**04-10-2019 Town Council Meeting**  
**Responses to Council Questions**

**ITEM #7: Consider an Application for Zoning Atlas Amendment - Independent Senior Housing, 2217 Homestead Road**

**ITEM #8: Consider an Application for Special Use Permit - Independent Senior Housing, 2217 Homestead Road**

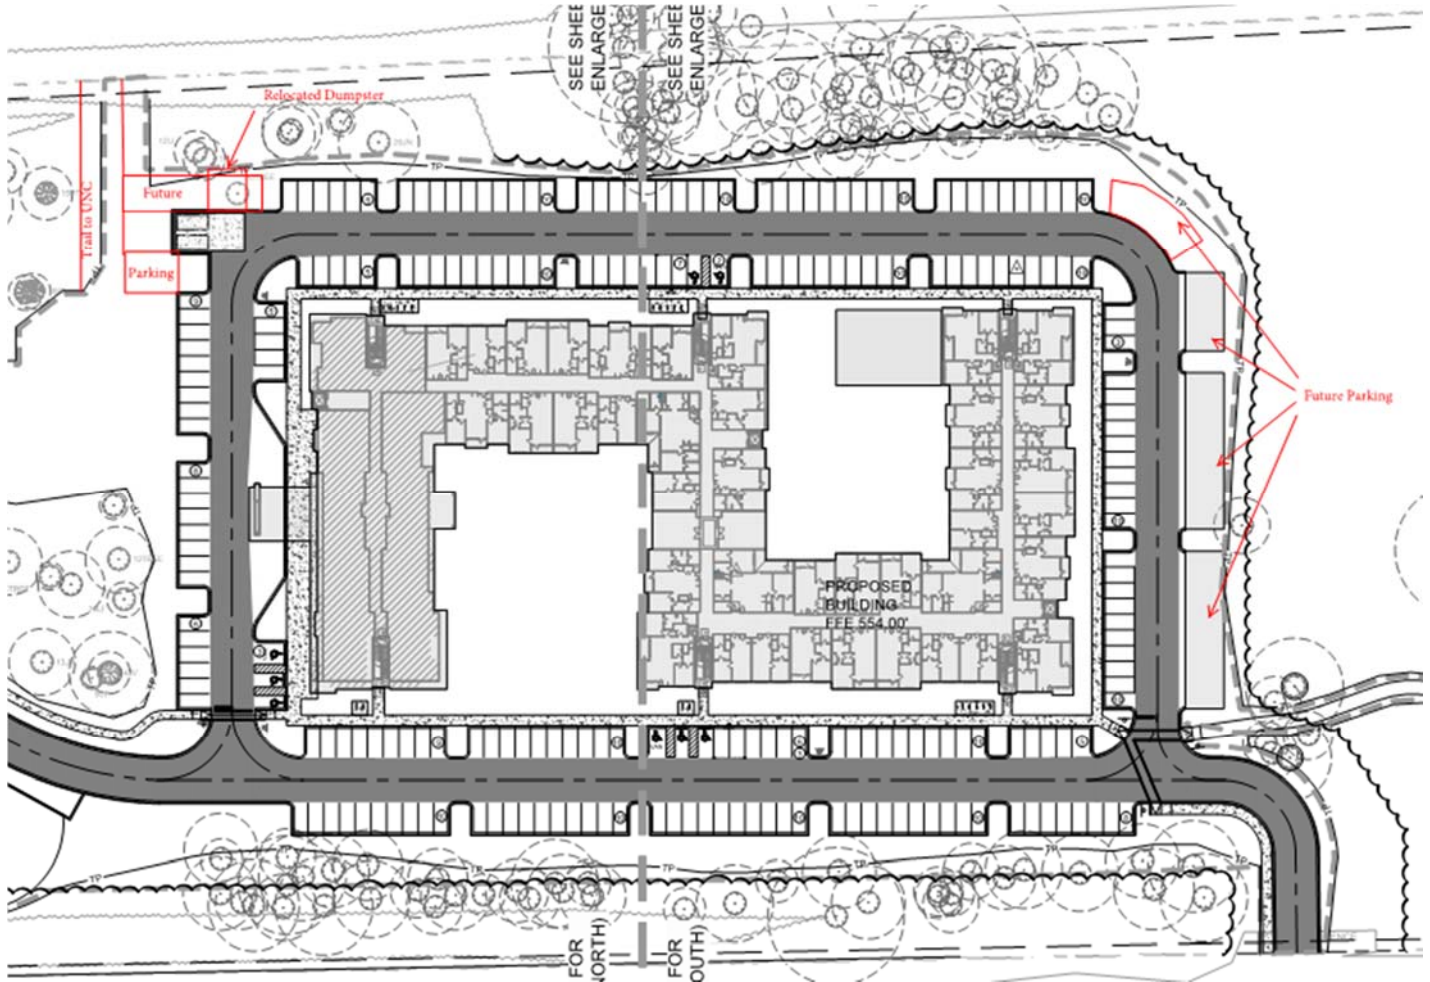
**Council Question:** What does the phasing plan for the proposed parking spaces look like?

**Staff Response:** *The graphic below indicates the location of the phased parking areas.*
